TECHNICAL ADVISORY COMMITTEE REPORT

FILE NUMBER: 24-DP-24

SUBJECT: Preliminary Site Plan review for an approximately 2,490 SF Warehouse Building

WAREHOUSE METAL BUILDING
 6013 RODMAN STREET
 HOLLYWOOD, FL 33023

SCALE: 1/4" = 1'-0"

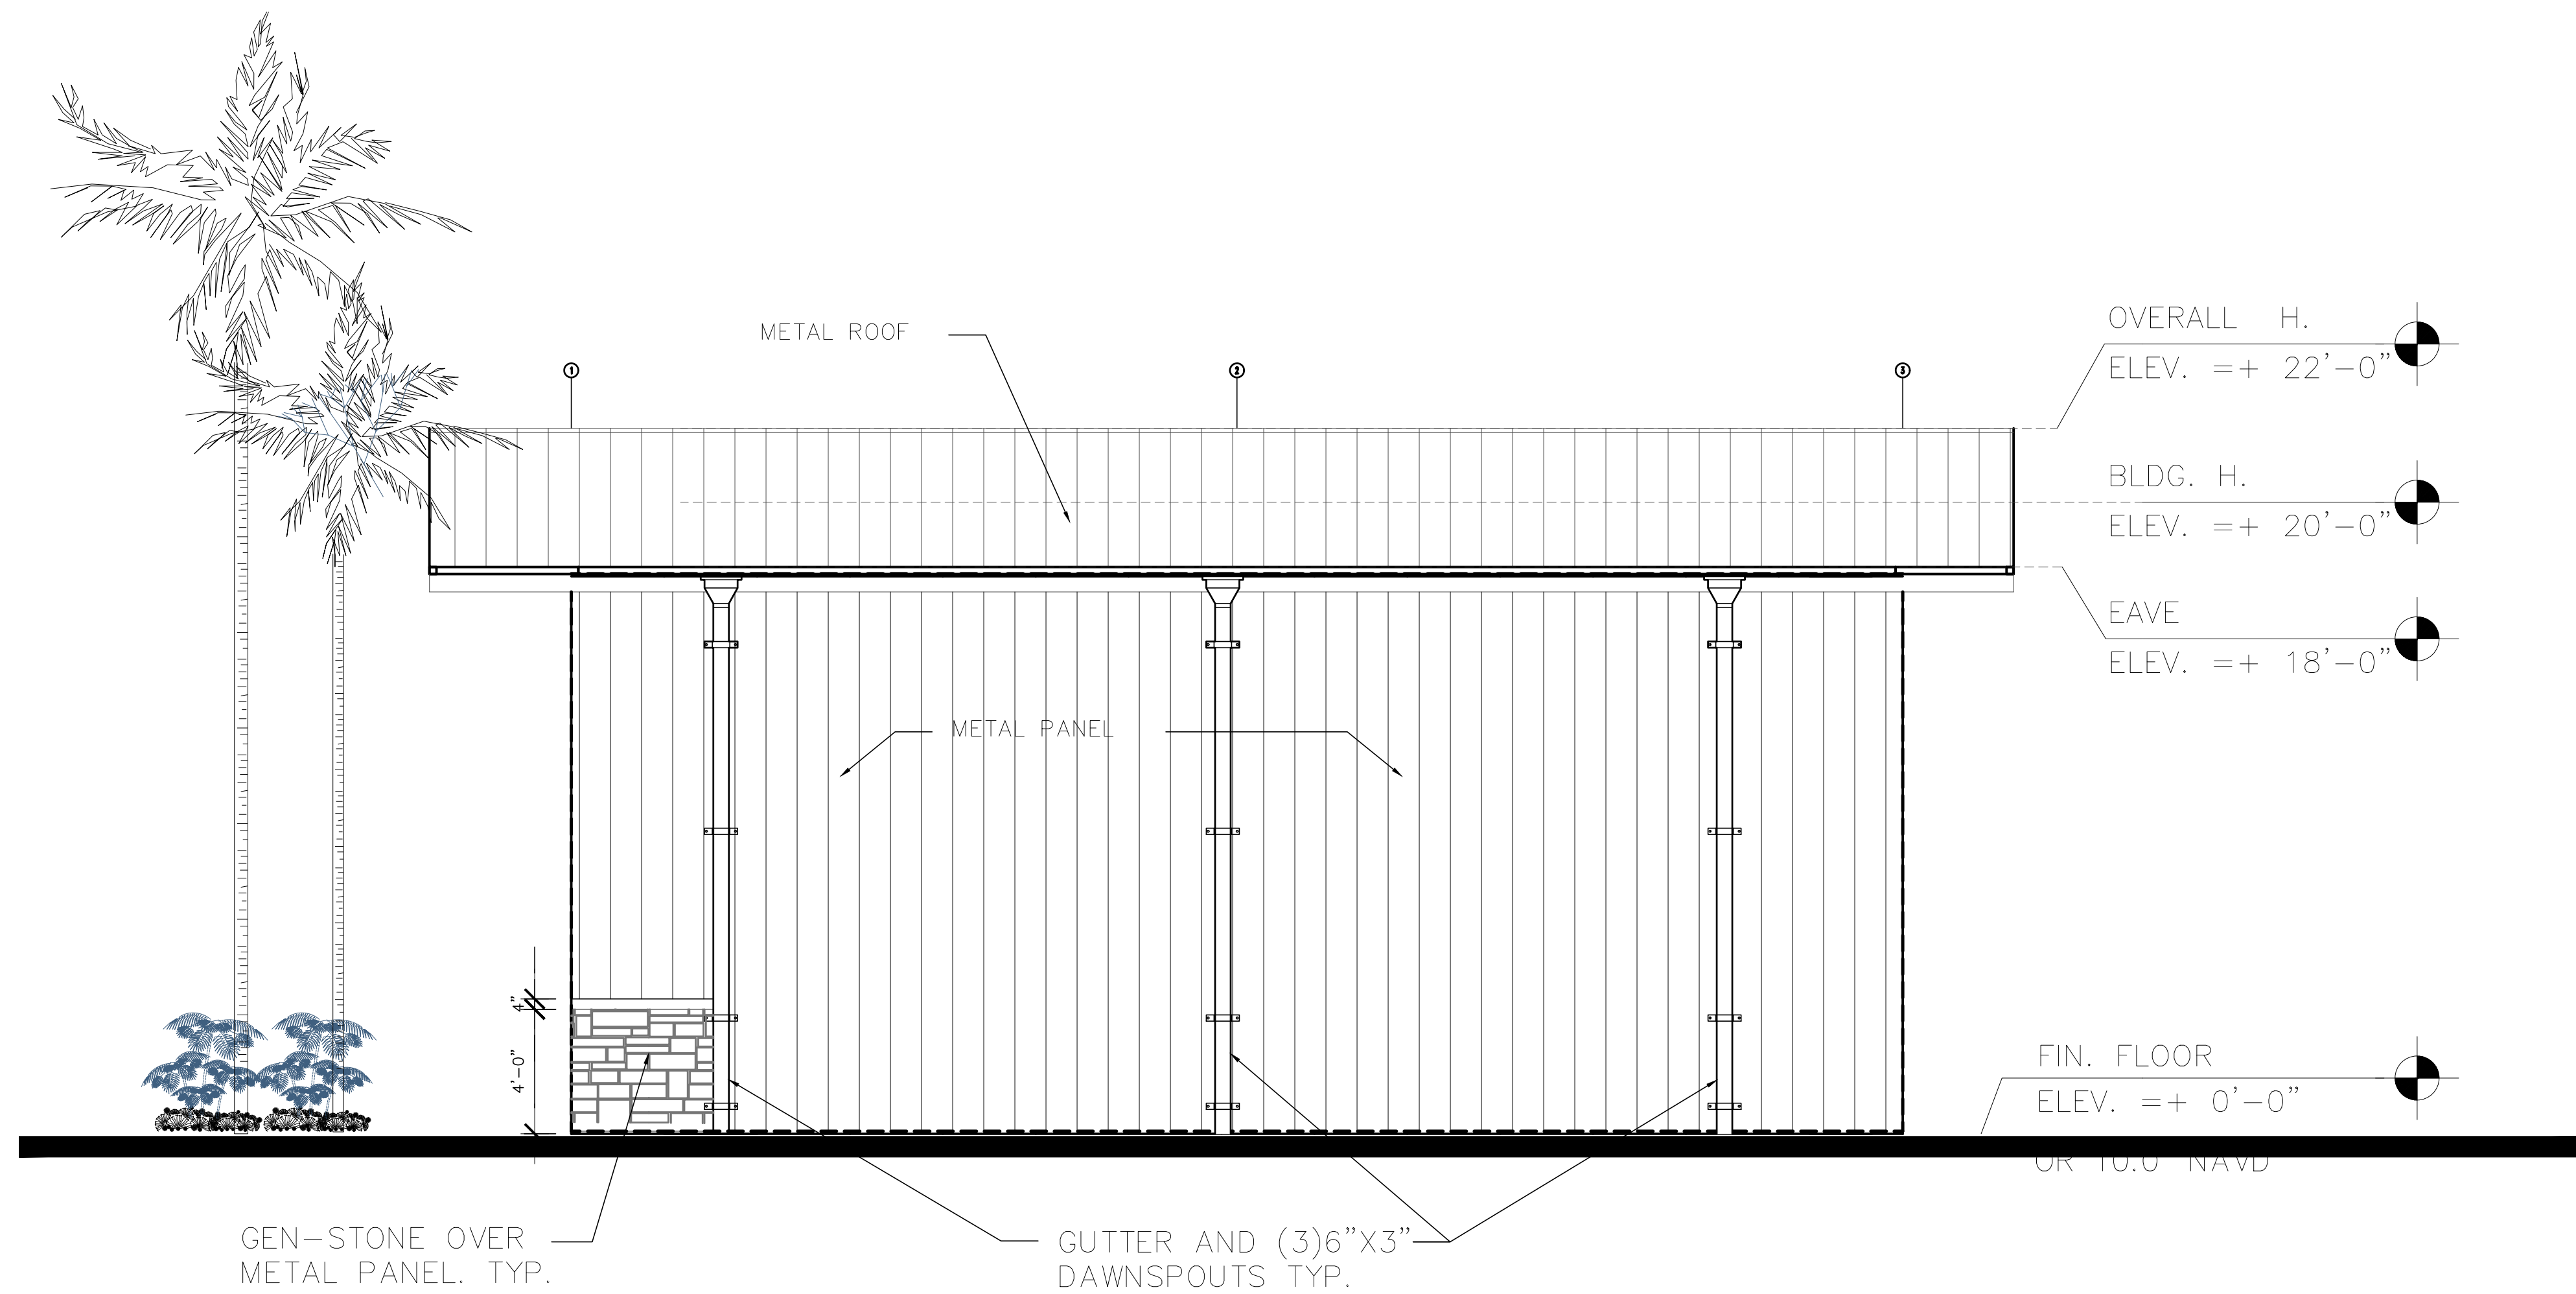
- 1. Provide material legend elevations. **PLEASE SEE MATERIAL SHOWED ON ELEVATIONS, A-2.0 AND A-2.1**

19. Add dimensions to the openings on the elevations on Sheet A-2.0 and on the site plan SP-1. **PLEASE SEE THE REVISED SITE PLAN SP-1 AND SHEETS A-2.0.**

20. Label the height of the entrances, exits, and doorways on the elevations on A-2.0. **PLEASE SEE REVISED SHEET A-2.0.**
21. Please clearly call out in the plans for swales to be restored along Rodman Street. This should be restored with grass to the City of Hollywood Typical Swale Grading Detail and Turf Restoration Detail, please include details in plan set. **A NOTE WAS ADDED TO THE PLAN C2.**
